Alert Service Bulletin No 33

(a) No.:	33
(b) Revision / Date	0 / 04 May 2022
(c) Title:	ALUGAS Cylinders - Temporary withdrawal from service
(d) Description:	Temporary withdrawal from service of CB2990 (Alugas) cylinders
(e) Applicability:	All hot-air balloons (from all manufacturers) fitted with CB2990 (Alugas) cylinders
(f) Effectivity:	Fuel cylinders Part Number CB2990 (Alugas) cylinders having serial numbers: OC25001 to OC25202 QI14001 to QI14494 Note: This serial number range covers all CB2990 (Alugas) cylinders currently in service. These fuel cylinders are known to be installed on, but not limited to, hot-air balloons and airships manufactured by Cameron Balloons Ltd, Colt Balloons, Lindstrand Balloons Ltd (LBL), Lindstrand Hot Air Balloons Ltd, Sky Balloons, Thunder Balloons, and Thunder & Colt

Figure 1 - Section indicating Valve Plate

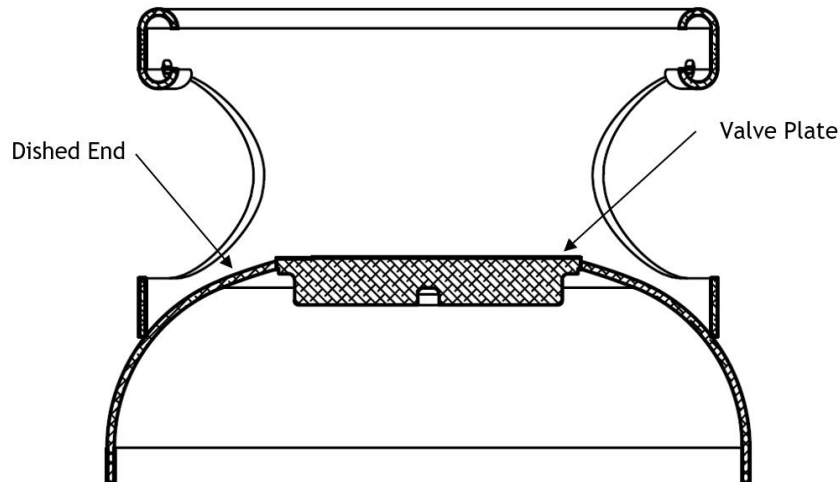
Five CB2990 (Alugas) cylinders have developed cracks in the weld between the cylinder valve plate and the upper dished end. These cracks allow the release of propane from the cylinder. Failures have been observed during periodic inspection (hydraulic pressure test), and leak test. All the in-service failures seen to date have been from the batch of cylinders with serial numbers starting OC.

To address this potential unsafe condition this service bulletin is issued to temporarily withdraw all CB2990 (Alugas) cylinders from service pending investigation of these failures.

Affected Cylinders are prohibited from further flight.

Within 24 hours of receipt of this bulletin affected cylinders must be checked for leaking around the interface between the cylinder valve plate and the upper dished end using leak detector fluid. Any cylinders found to be leaking must be emptied of fuel immediately. A pilot may carry out this inspection. A satisfactory leak check **does not** release the cylinder to service.

Within 7 days of receipt of this bulletin affected cylinders must be emptied of fuel.
